Docket: NRC-2011-0012
Low-Level Radioactive Waste Disposal

Comment On: NRC-2011-0012-0077
Low-Level Radioactive Waste Disposal

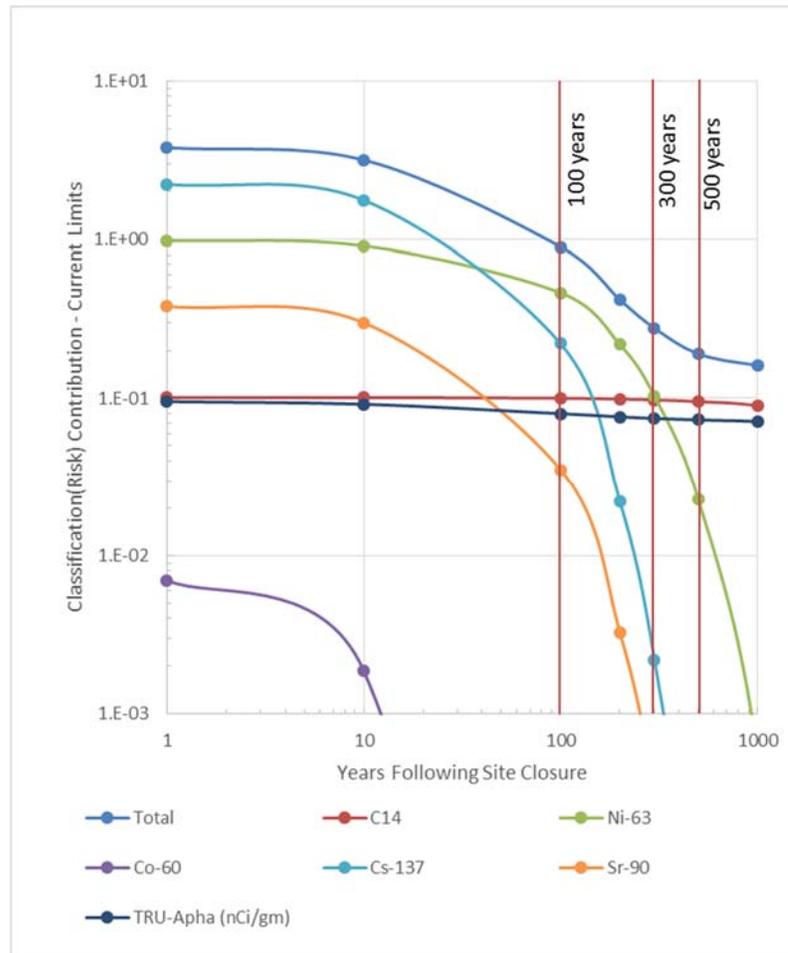
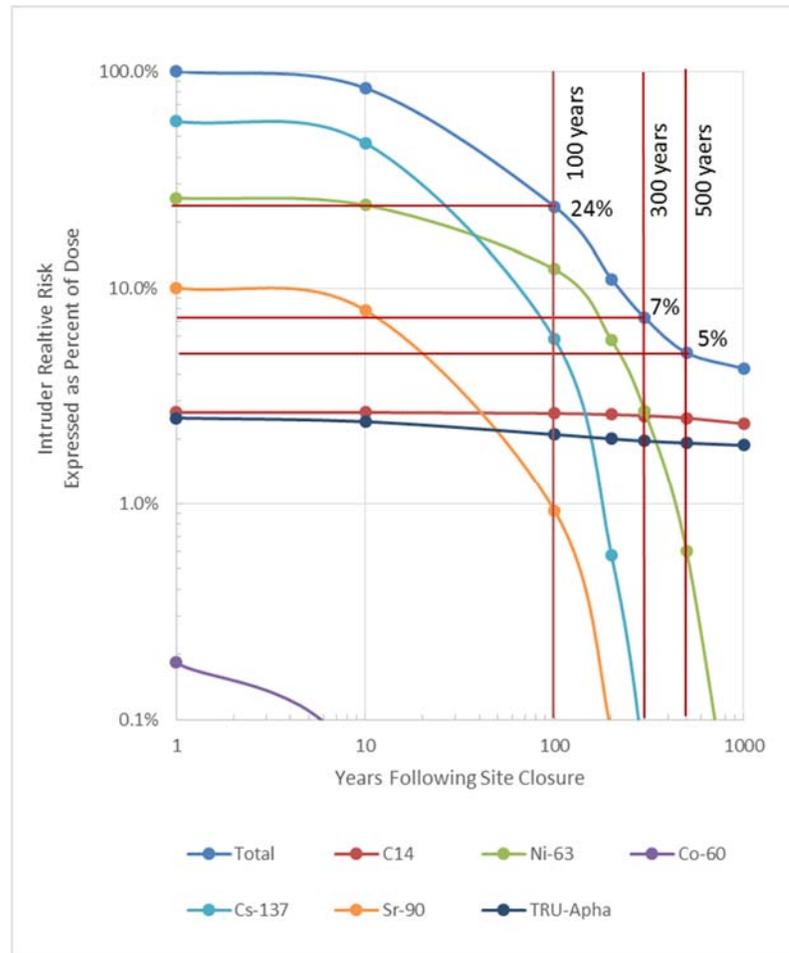
The concentration values identified above can be divided by the existing 10 CFR 61.55 concentration limits as a measure of risk. The results are shown below.

For the first 300 years disposal risk is driven almost entirely by ^{137}Cs and ^{63}Ni . After 500 years, only ^{14}C and TRU continue to stand as dominant risk contributors, but at reduced levels from that observed during the first 300 years. Neither ^{14}C nor TRU in this mixture are ever more than about 10% of the Class A limits (EPRI, 2010).

This data indicates that the relative total intruder risk at 100 years is 24% of the intruder risk at the time of site closure. However, based on the international studies referenced above, the more probable time for the failure of institutional controls is 300 years after site closure. The relative total intruder risk at 300 years is 7% of the risk at the time of site closure. As such, when 100 years is used as the time period for intrusion (coincident with the loss of active institutional controls), the risk is three times higher compared to when intrusion is more likely to occur. While the proposed rule assumption that inadvertent intrusion occurs immediately after the loss of institutional control is a reasonable and conservative approach, the time of the loss of institutional control should be re-evaluated.

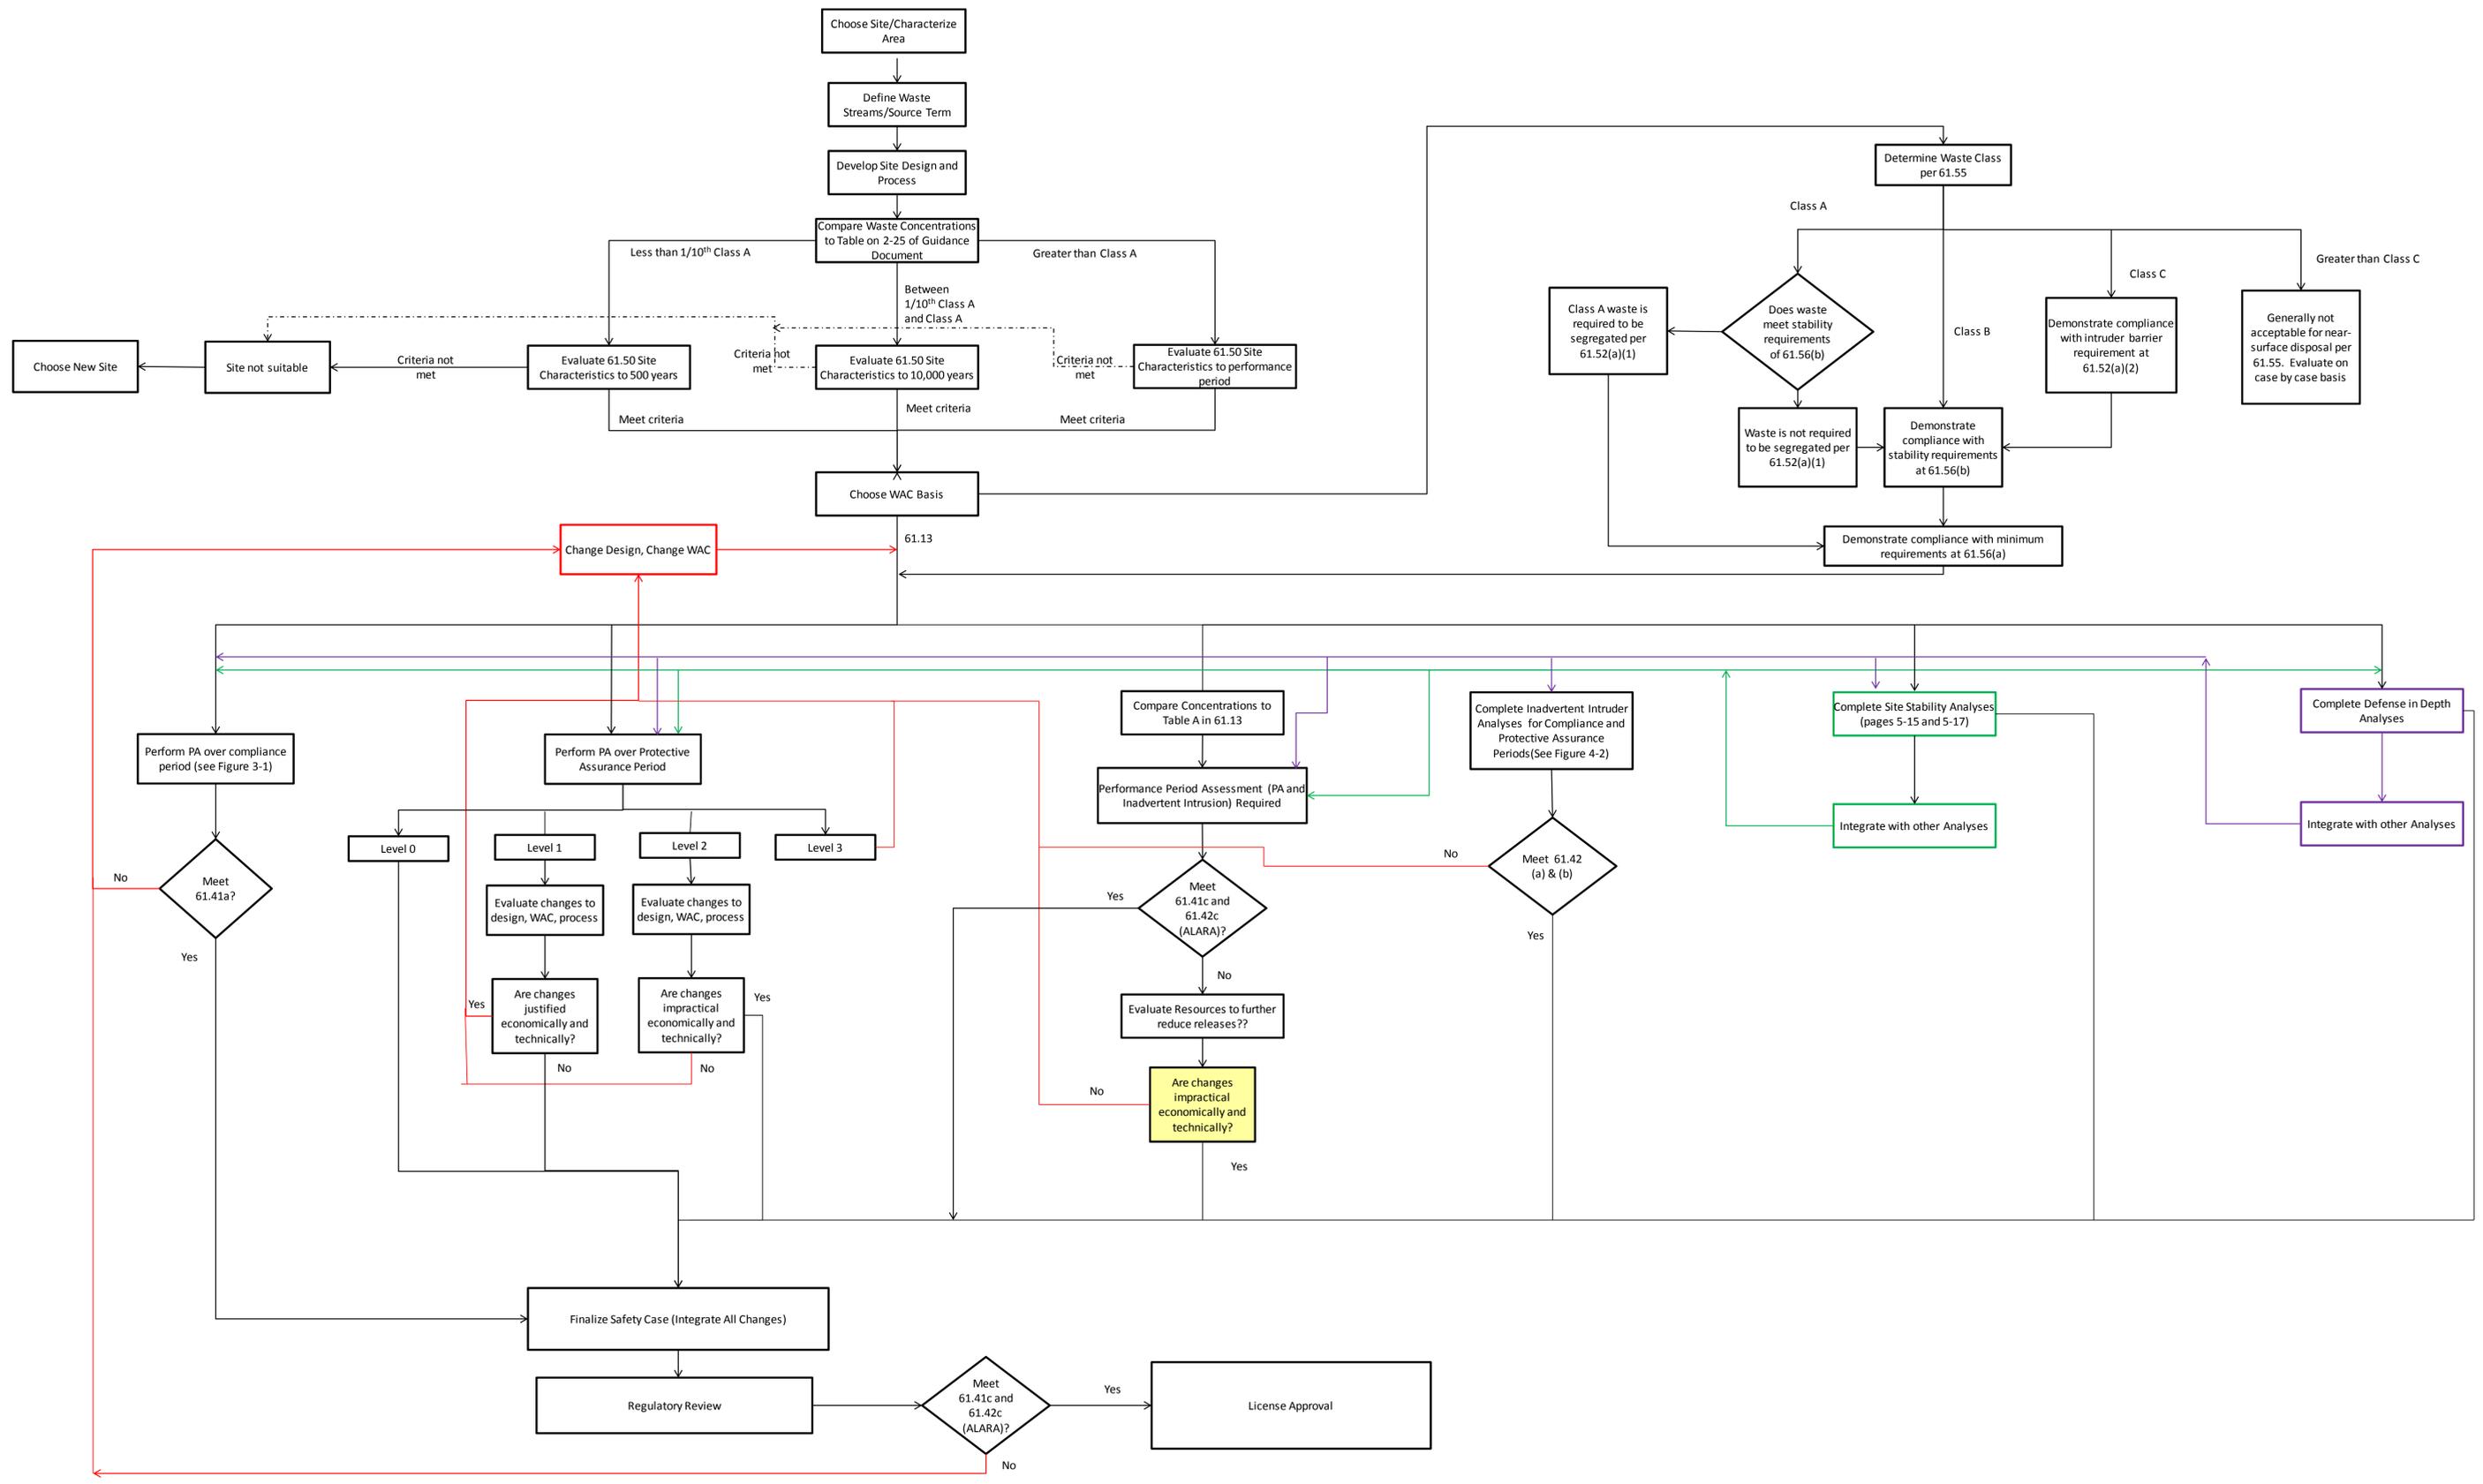
We attempted to create a flowchart to fit the pieces of the proposed rule together (see Figure 1). This flowchart clearly illustrates the cumbersome nature of the process. We recommend several changes that should streamline the process, including using a two-tier system. These are discussed in further detail in the following sections.

61.41	Delete subsection (b) to be consistent with the two-tier system.	Technical
61.42	Delete subsection (b) to be consistent with the two-tier system.	Technical

61.44	The words “and protective assurance” should be removed so that the stability analyses is only required for the compliance period.	Technical
61.51(a)	Delete the phrase “defense-in-depth.” This wording suggests that a site would have multiple layers or redundant systems built into the design. This is a misapplication of the concept of defense-in-depth for a disposal site. Defense-in-depth is provided by the additive protection arising from proper site selection and design and there should be no specific requirement for DID to be built specifically into the site design. The extent to which design features are necessary to ensure compliance with the performance objectives should be driven by the overall technical analyses, not a DID focused “analysis.”	Technical
